LOUISE BERRY DRIVE
BROOKLYN, CONNECTICUT

DATE: 4/23/2020	DRAWN: DNE
SCALE: 1" = 40'	DESIGN: NET
SHEET: 6 OF 9	CHK BY: ---
DWG. No: CLIENT FILE	JOB No: 20014

Subject: RE: Pollock / Louise Berry Drive 51-Unit Condominium Project - Brooklyn Water Pollution Control Authority (BWPCA) -Commitment to Serve - Sanitary Sewer.

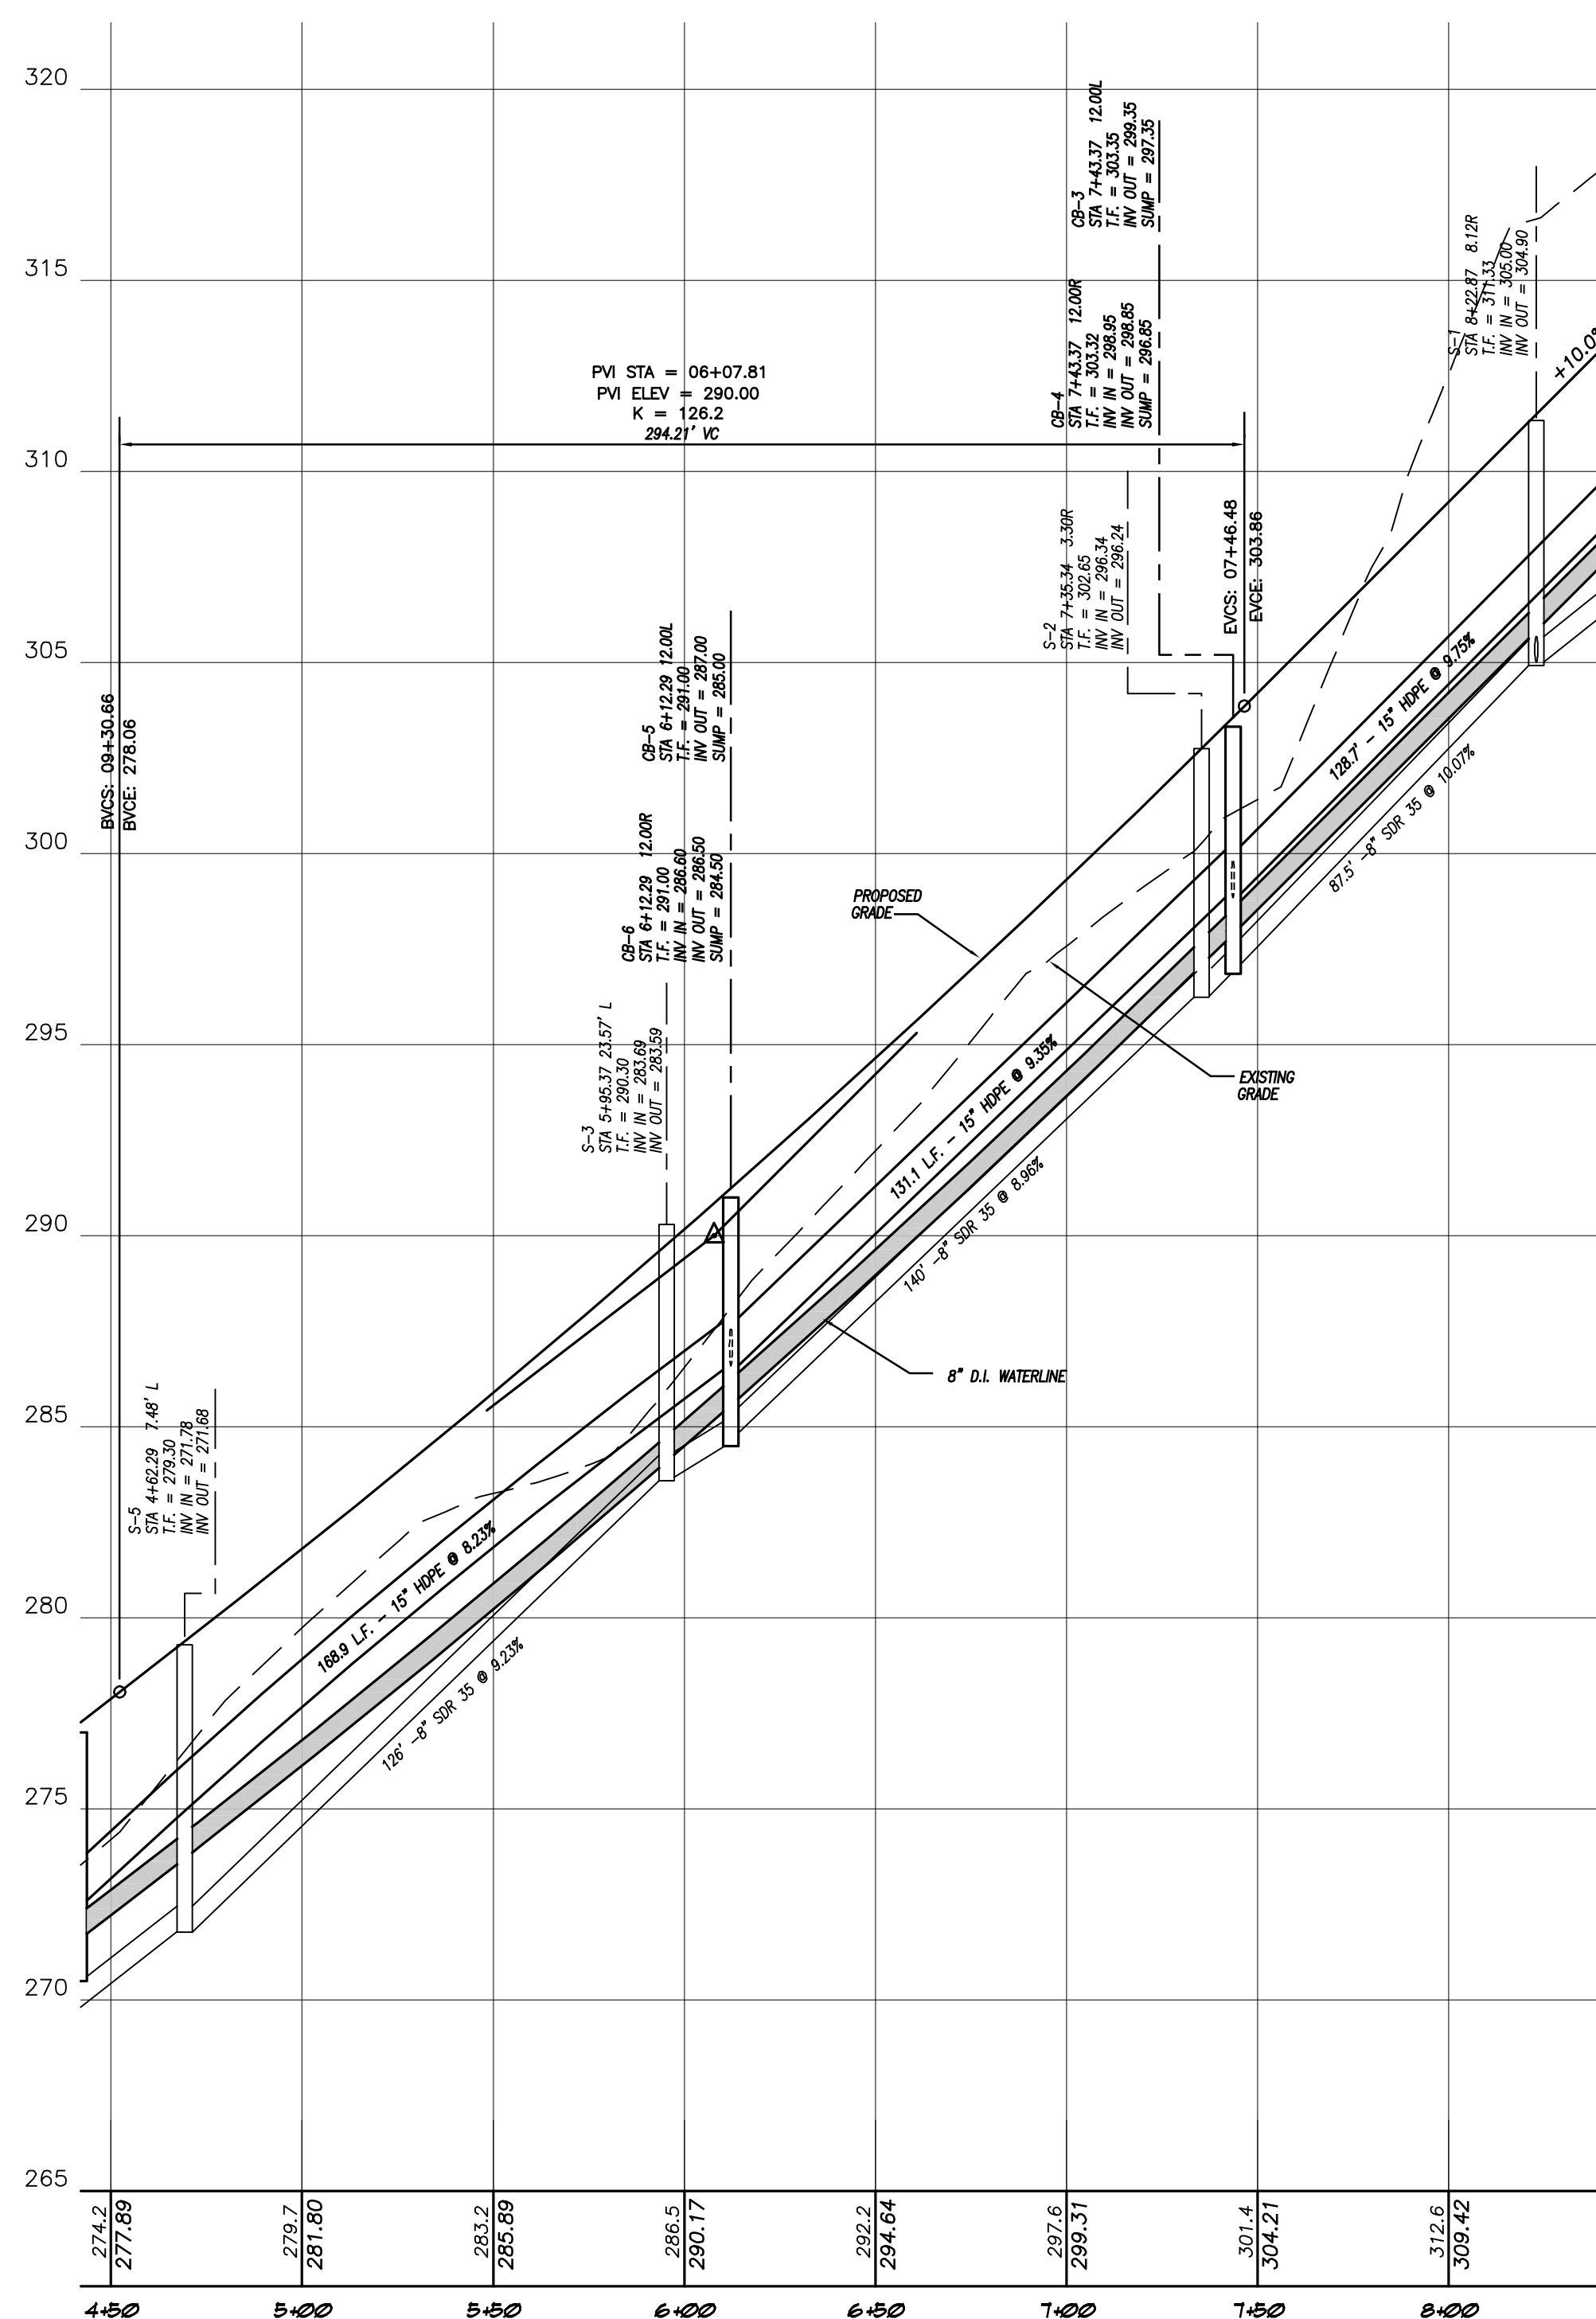
1. We will require that the main trunk line through the site be dedicated to the Town of Brooklyn Water Pollution Control Authority under a 30-foot wide easement (15-feet each side of the line) for ownership, control, and maintenance responsibility. The permanent easement over the main trunk line will need to be created, approved by BWPCA and recorded in the Town of Brooklyn land records prior to any connections to the system.

2. The eastern terminus manhole in Louise Berry Drive be a minimum of 8-feet deep from top of frame to invert and an 8-inch SDR 35 stub be installed a minimum of 1 pipe length (20-feet) at 0.4 ft/ft slope and capped in the east facing invert.

3. We require that the entire system be constructed/installed in accordance with the Town of Brooklyn WPCA construction standards by the Developer. We will require the system be inspected by our representatives during construction, tested by the Developer and certified by his engineer and 'cleared for use' by our representatives before the system can be used.

4. Unless you provide us with documented proof of anticipated usage, we are calculating your anticipated usage at 22,950 Gallons per day. (51 units X 450 GPD/per unit).
